Safety Recall

N262551720 Rearview Camera Inoperative

Release Date: May 2026

Revision: 01

7136011

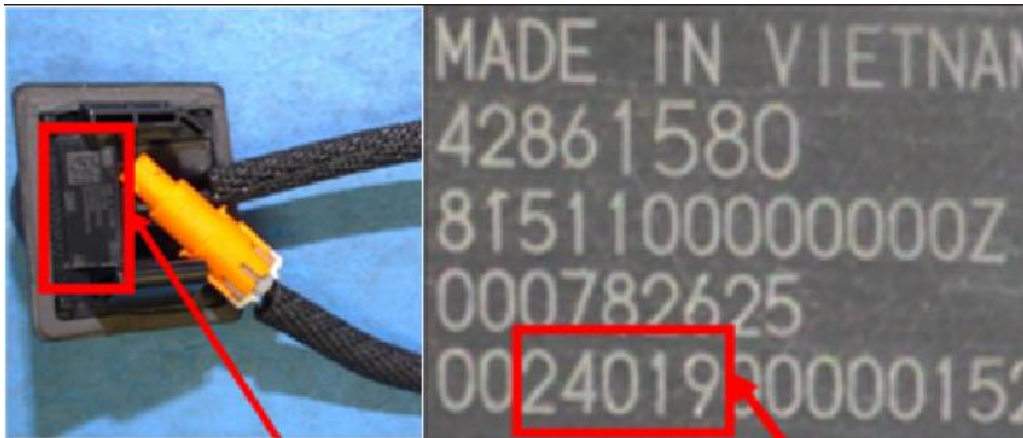
2. Locate the identifying information inscribed on the bracket of the camera as shown above.

3. Identify the Julian date listed in the bottom row of the inscription. It may be helpful to use a magnifying glass or camera to enlarge the text.
 - If the Julian date indicates the camera was built **BEFORE** Julian date 24336, proceed to the next step.
 - If the Julian date indicates the camera was built **ON or AFTER** Julian date 24336, reinstall the camera and no further action is required.
